PROPOSAL REQUEST

Whitewood Creek - Phase 5

PROPOSAL REQUEST NO.: 1

Description: additional tree removals and additional grass seeding. Unit prices provided during bidding must be used for tree removals and seeding. Brush removal

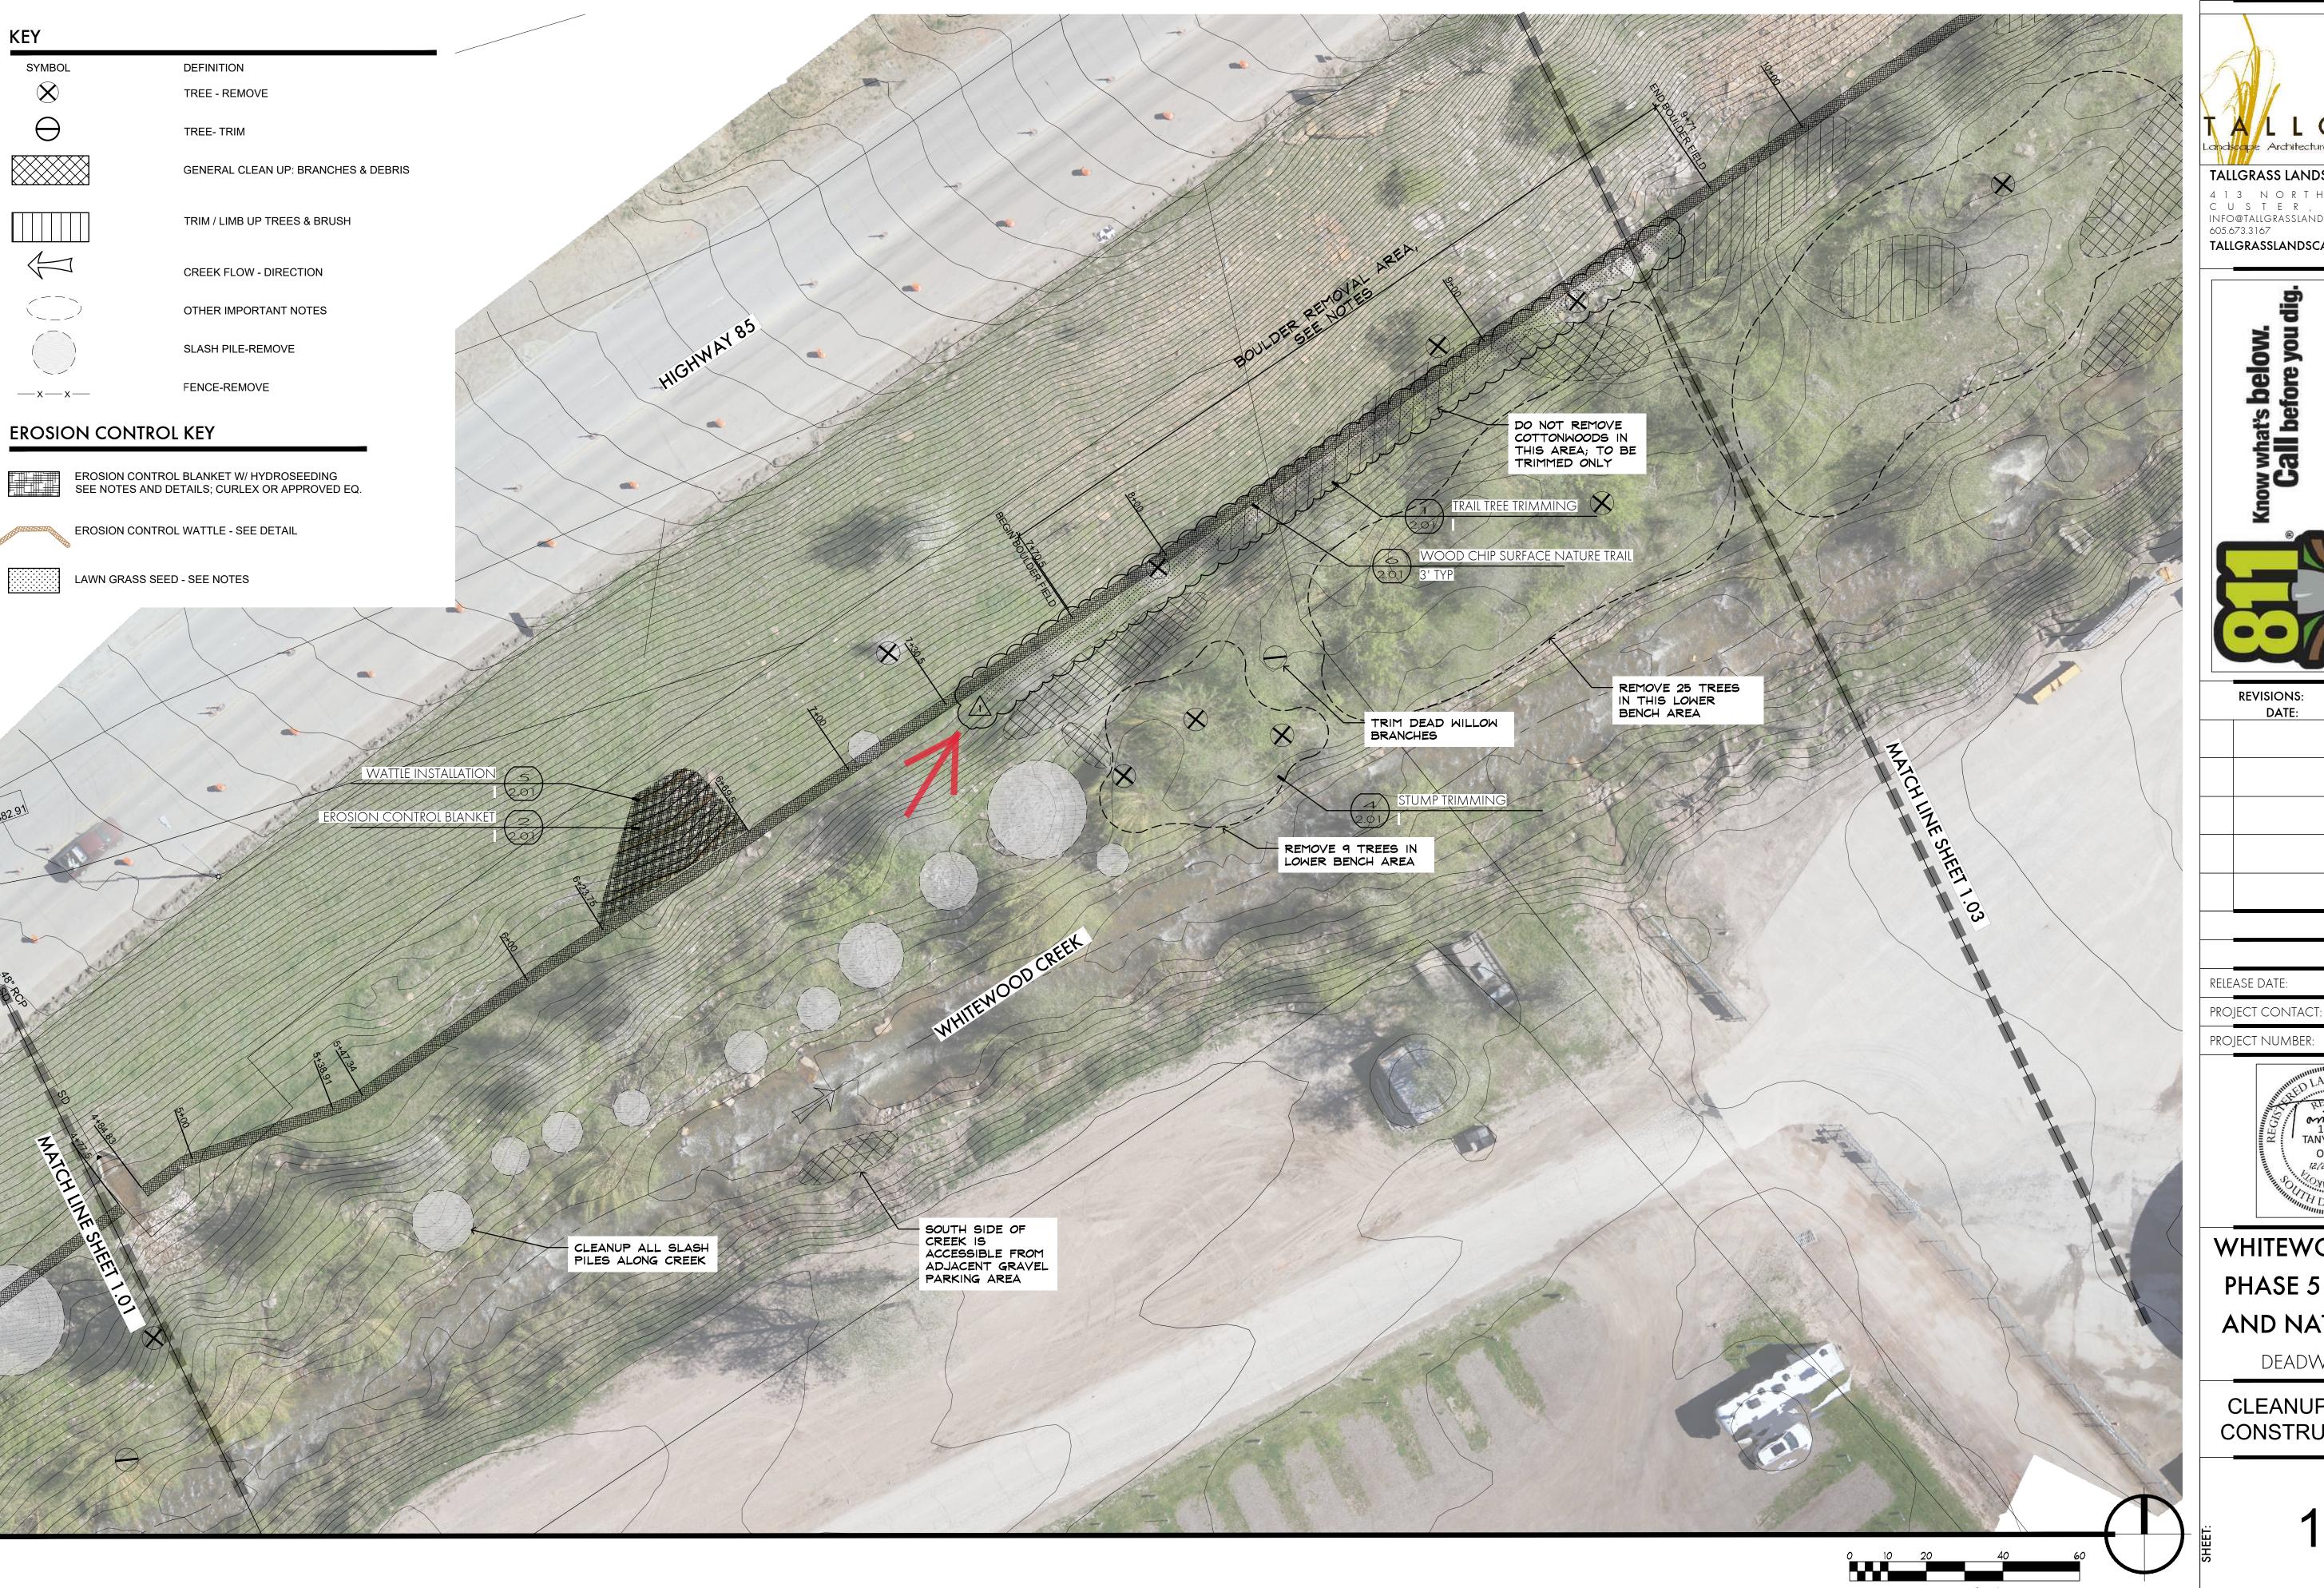
Remove the two trees indicated – the crooked willow and the next willow downstream

Remove the center willow in a grouping of three

Remove small dead aspen brush in this area on the lower bench adjacent to willow removals – remove in an approximately 10' swath

1.02

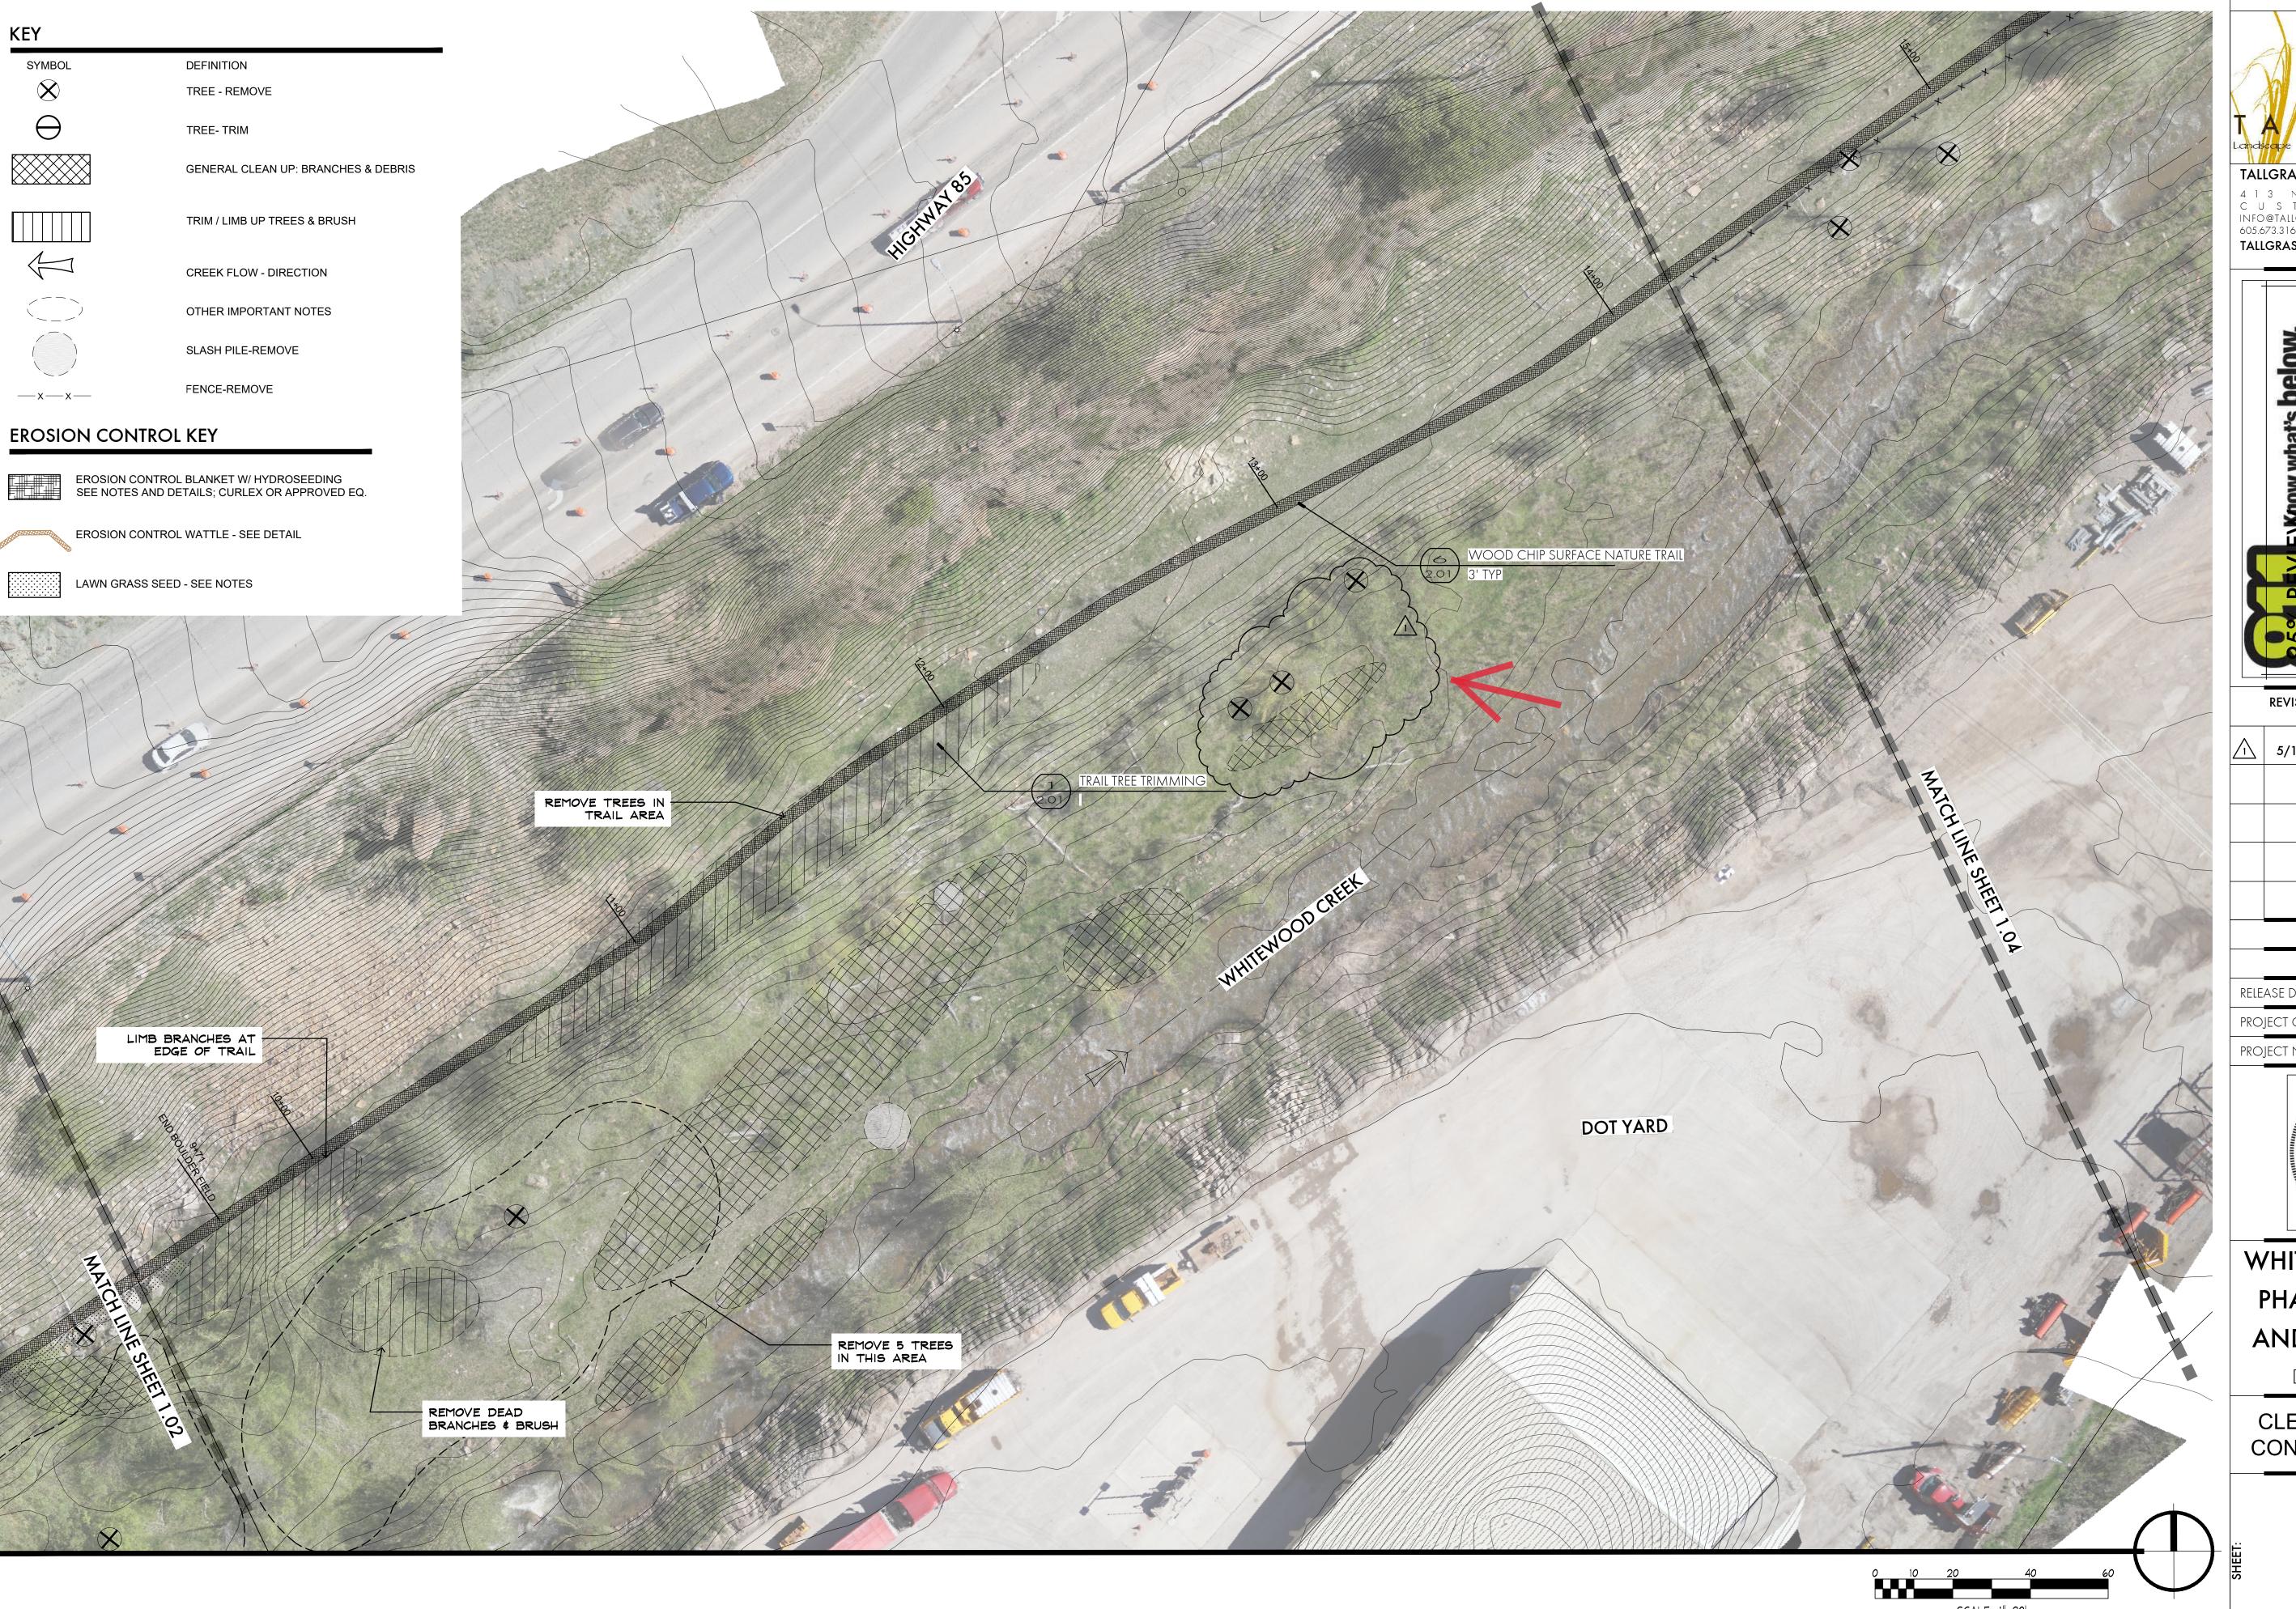
- 1. Remove three >24" Willow trees in the locations indicated (photos also included)
- 2. Remove approximately 25 trees / brush clumps ½" and smaller on the lower bench in location indicated. Most of the trees are aspen trees that have been damages by deer. Please retain aspen trees that are starting to bud out at the edges of the removal area.
- 3. Add seeding on the slop below the trail cut in the location indicated. Quantities are estimated to be approximately 1000 sf.

See revision 1 on sheets 1.02 and 1.03 Photos of locations specified, below
